SITE DEVELOPMENT CONSTRUCTION PLANS
HUNTINGTON NATIONAL BANK

TOWN OF PARKER PLAN SET

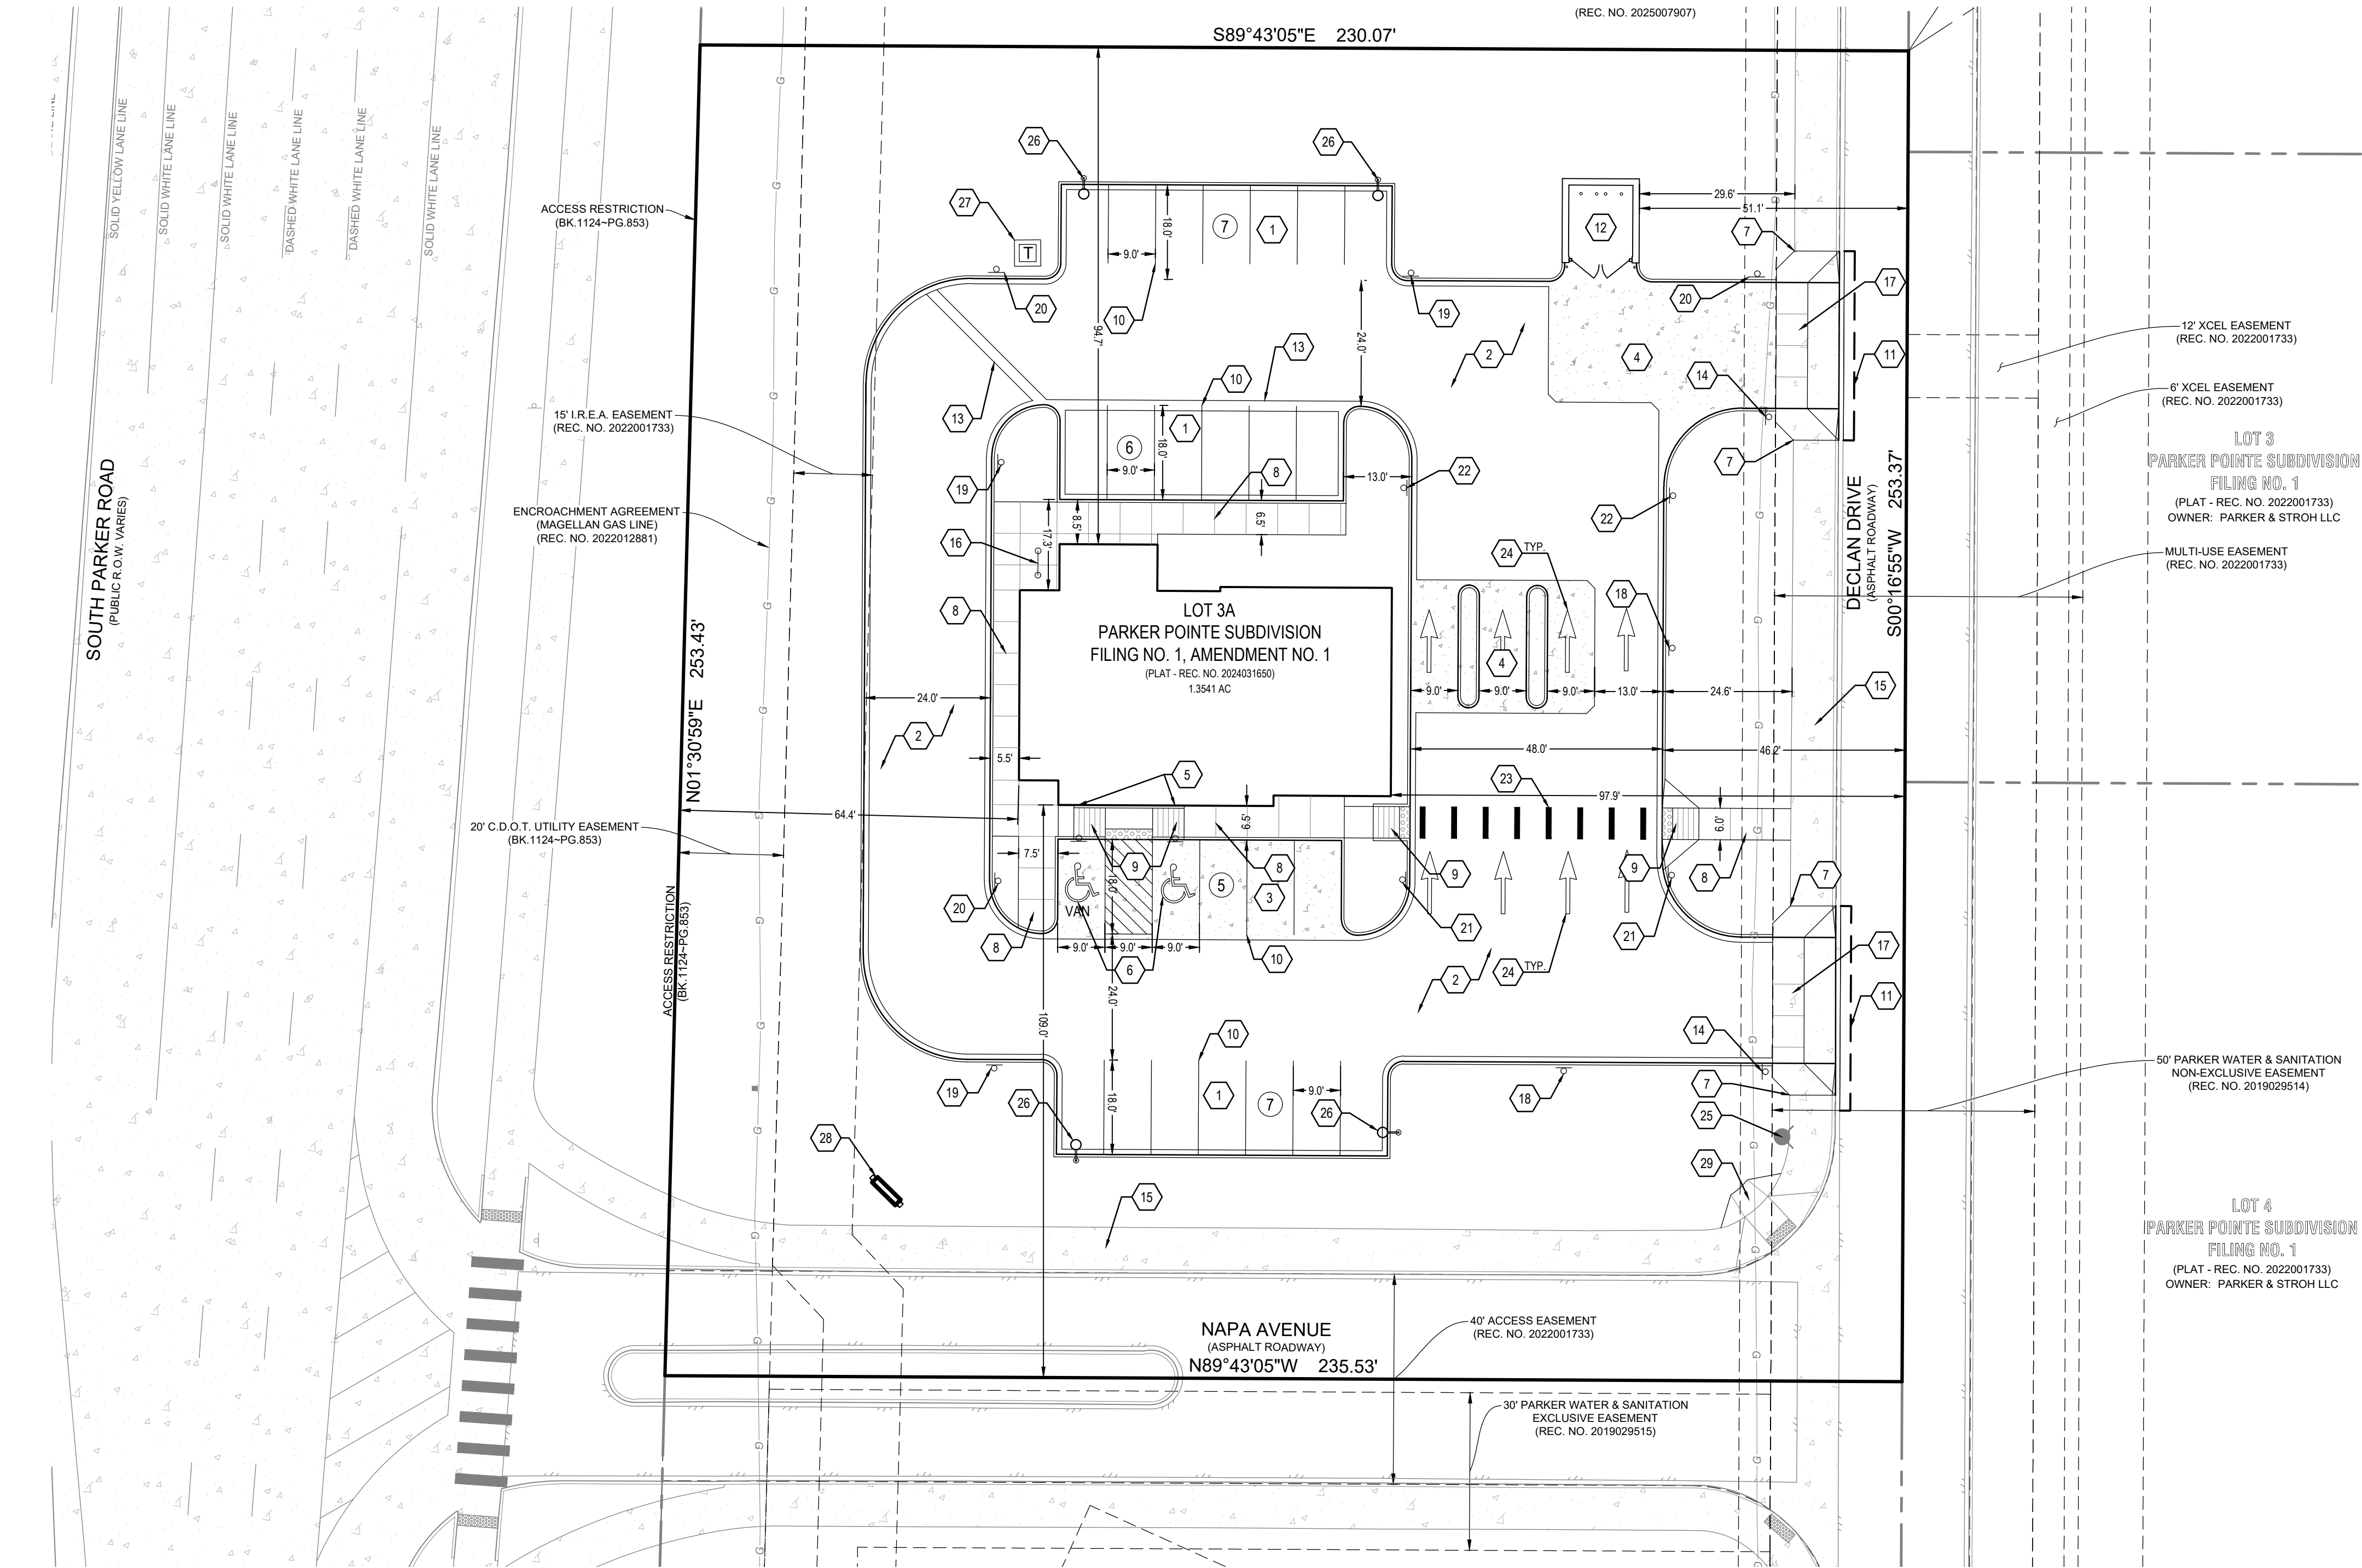
There did not appear to be retaining walls proposed within the grading plans. If so there are not wall proposed please remove this note, otherwise label and show all proposed retaining walls with top of wall and bottom of wall elevations within the grading plans.

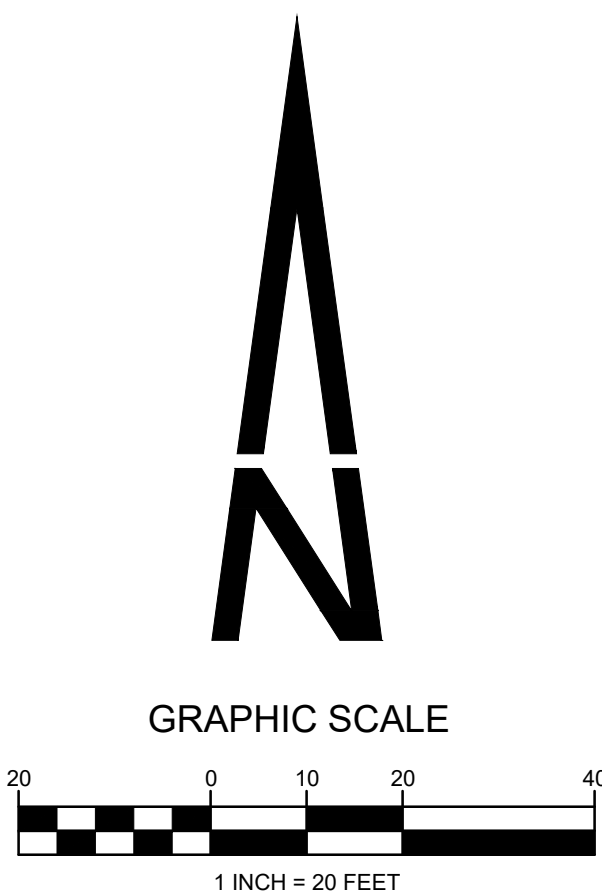
Provide the following note on the Overall Utility Plan: "ANY PROPOSED UTILITY CONNECTION WITHIN AN EXISTING ROADWAY WITHIN PUBLIC RIGHT OF WAY WILL REQUIRE A TOWN RIGHT-OF-WAY PERMIT PRIOR TO COMMENCING WORK. THE TOWN REQUIRES CONNECTIONS TO BE BORED TO THE EXTENT POSSIBLE, AND ANY STREET CUT ALLOWED BY THE TOWN WILL BE REQUIRED TO BE PATCHED ACCORDING TO THE TOWN'S CONSTRUCTION STANDARDS AND DETAILS. THE LIMITS OF PATCHING WILL BE DETERMINED BY THE TOWN AT THE TIME OF CONSTRUCTION. THE TOWN OF PARKER DOES NOT ALLOW ROADWAY CLOSURES FOR UTILITY WORK."
